ARKANSAS NUCLEAR ONE, UNIT 1

AMENDMENT TO FACILITY OPERATING LICENSE

Amendment No. 105
License No. DPR-51

SAFETY EVALUATION BY THE OFFICE OF NUCLEAR REACTOR REGULATION
SUPPORTING AMENDMENT NO.105 TO FACILITY OPERATING LICENSE NO. DPR-51
ARKANSAS POWER AND LIGHT COMPANY
ARKANSAS NUCLEAR ONE, UNIT NO. 1
DOCKET NO. 50-313

Figure 3.5.2-2C

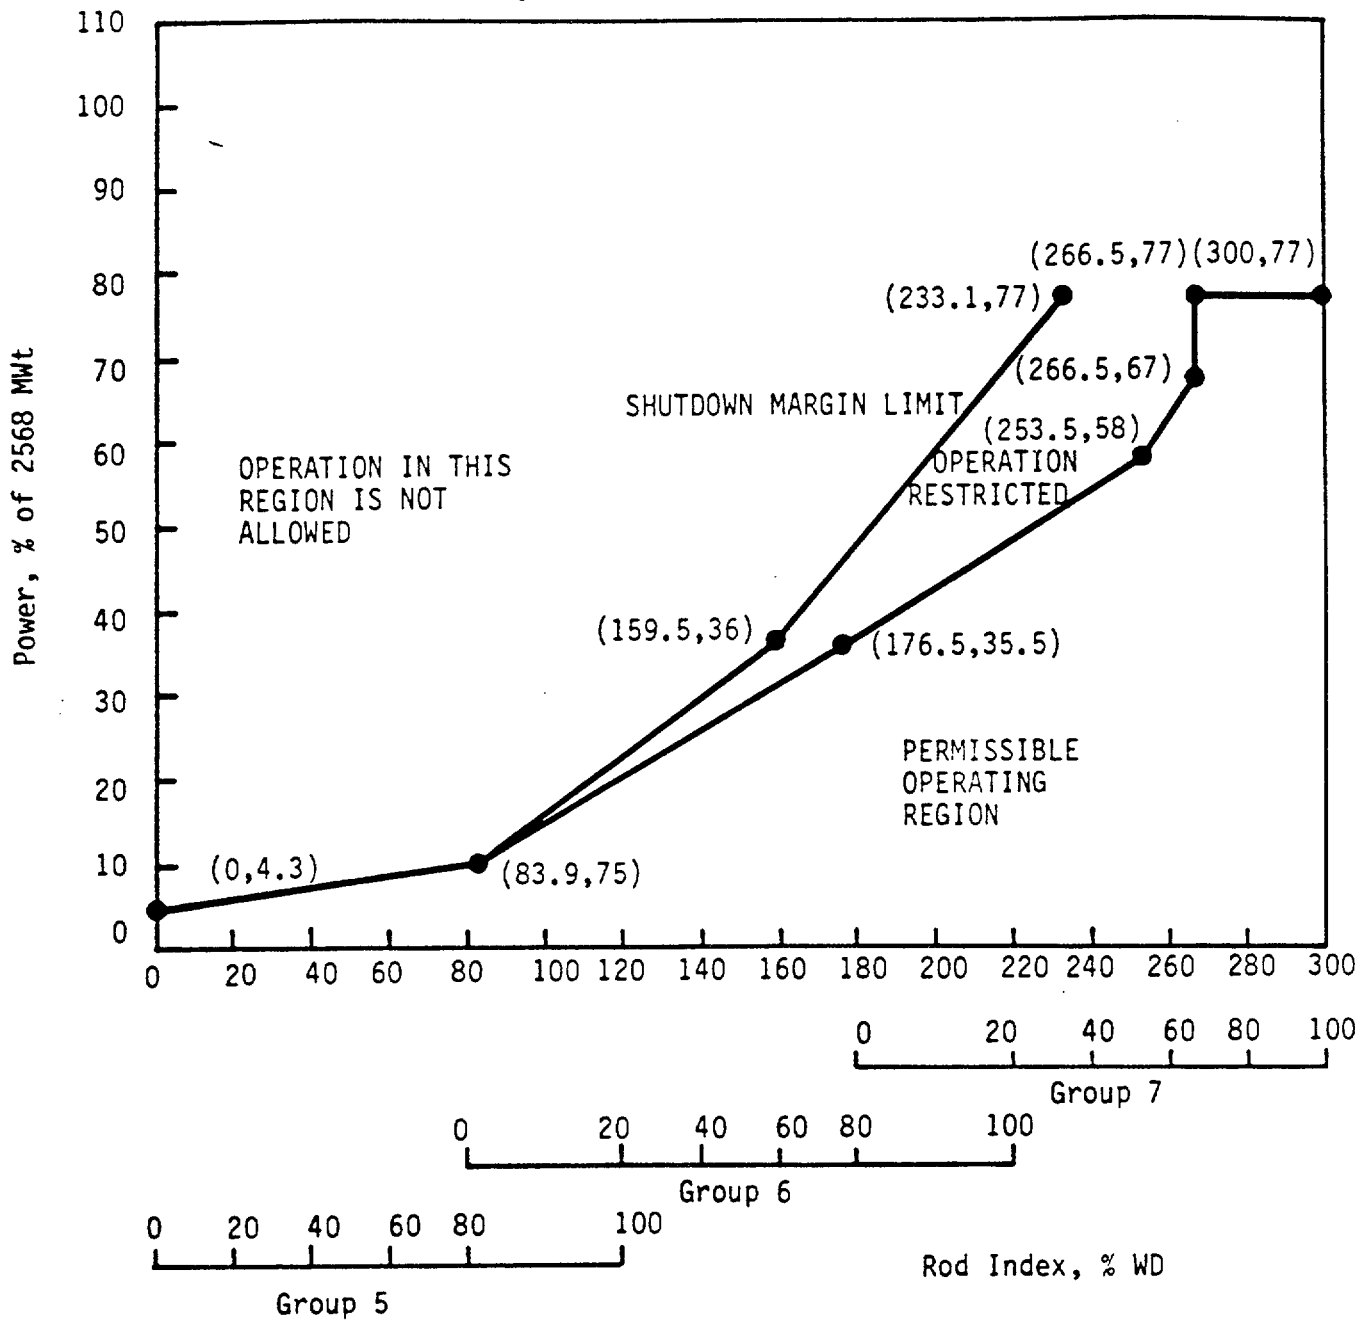
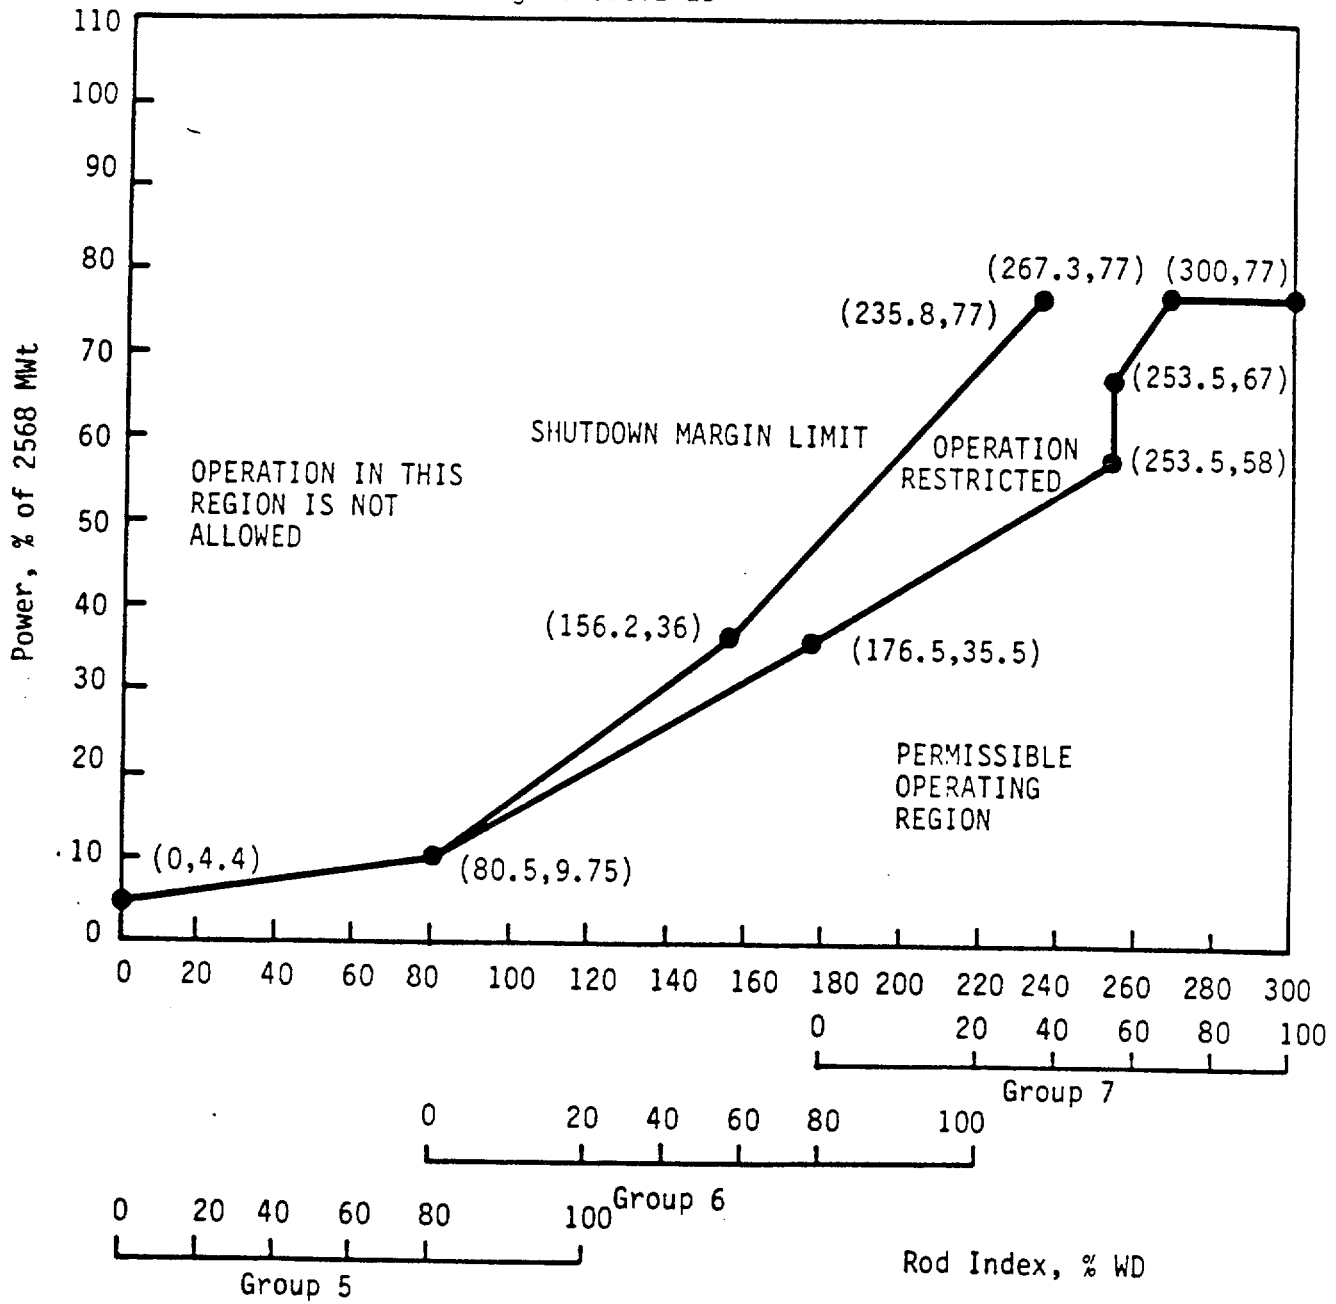
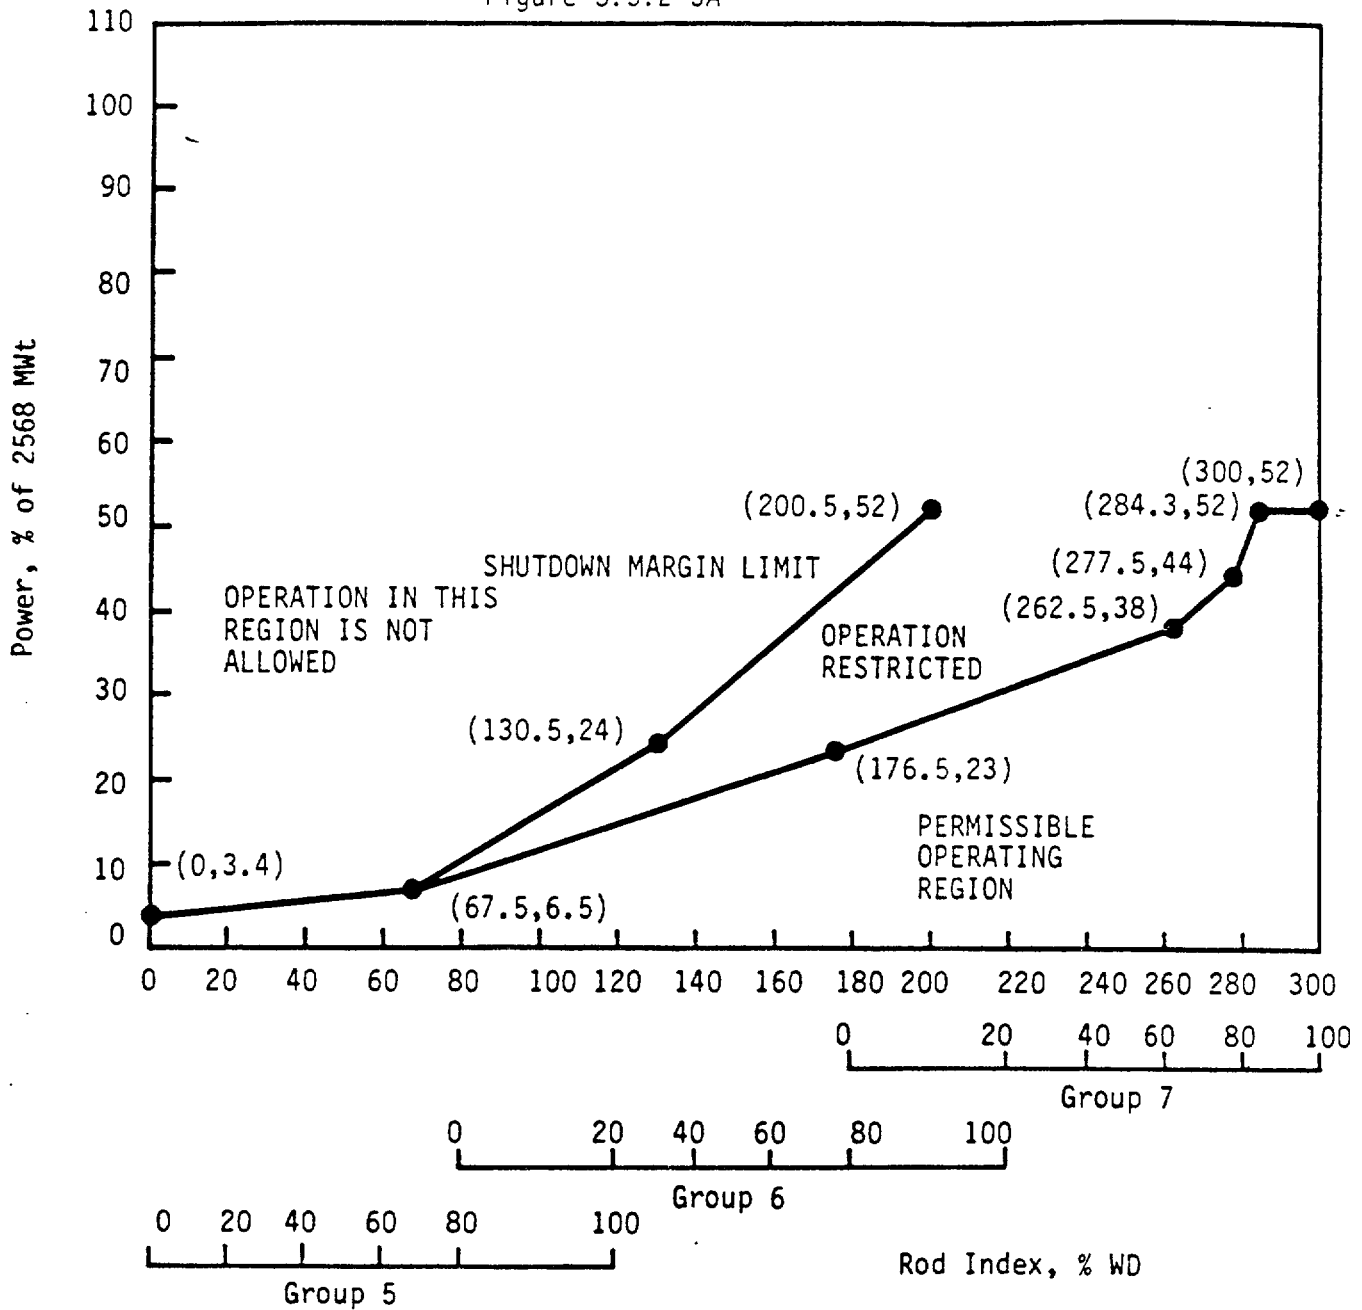
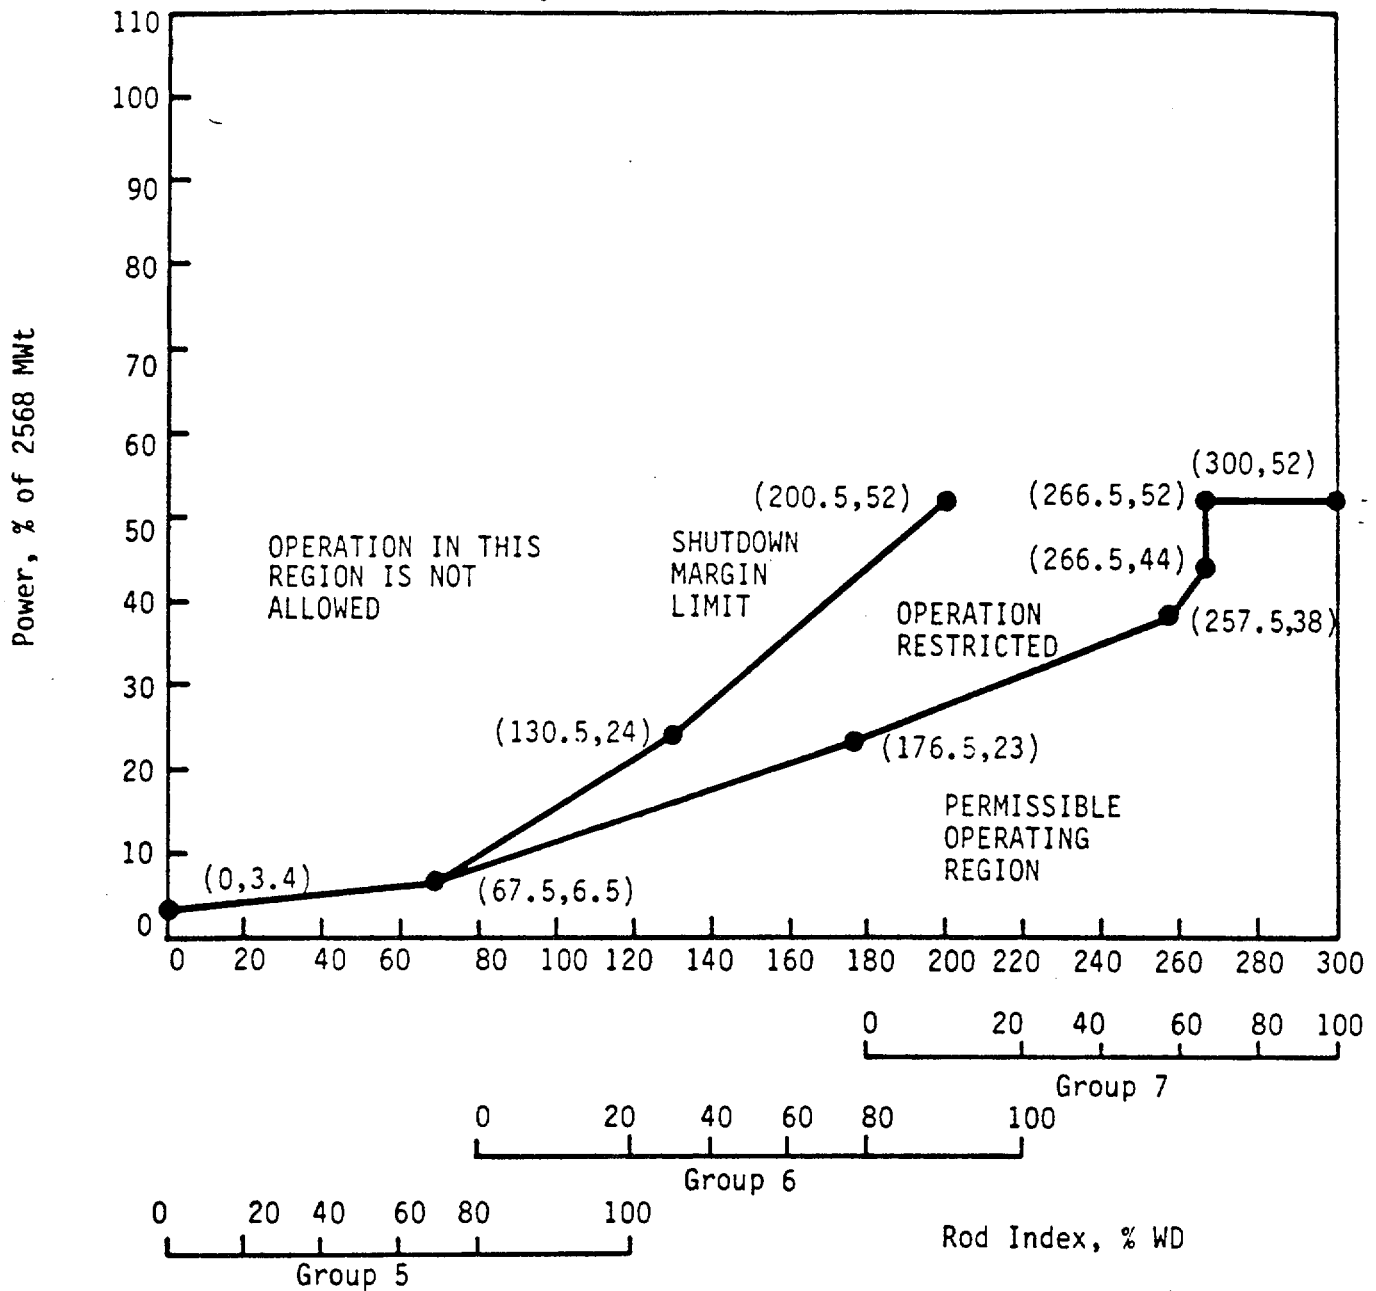
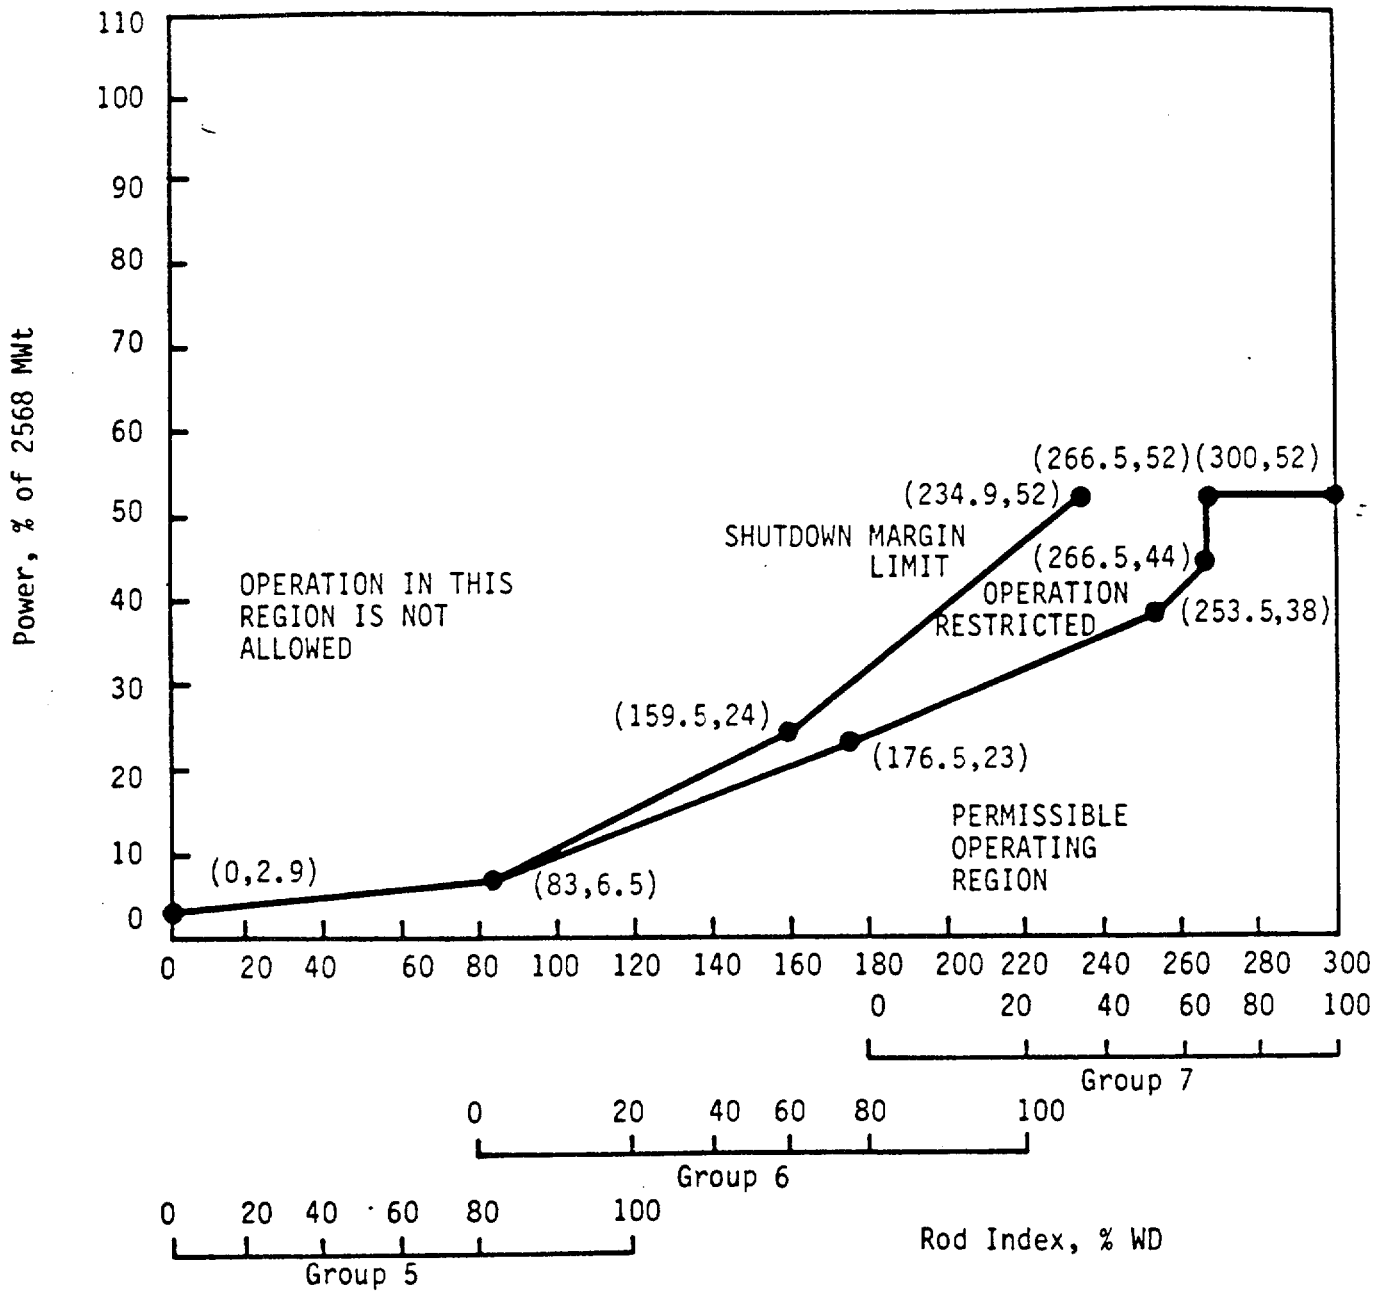
3. Except for physics tests or exercising control rods, (a) the control rod withdrawal limits are specified on Figures 3.5.2-1(A-D), 3.5.2-2(A-D), and 3.5.2-3(A-D) for 4, 3 and 2 pump operation respectively; and (b) the axial power shaping control rod withdrawal limits are specified on Figure 3.5.2-6(A-D). If any of these control rod position limits are exceeded, corrective measures shall be taken immediately to achieve an acceptable control rod position. Acceptable control rod positions shall be attained within 4 hours.

2. TS 3.5.2.4.1 Quadrant Tilt
The power level cutoff requirement has been deleted.
3. TS 3.5.2.5.3 Control Rod Positions
New control rod insertion limits are provided for 4, 3 and 2 pump operation, as well as a function of burnup interval. APSR limits are also provided as a function of burnup interval.
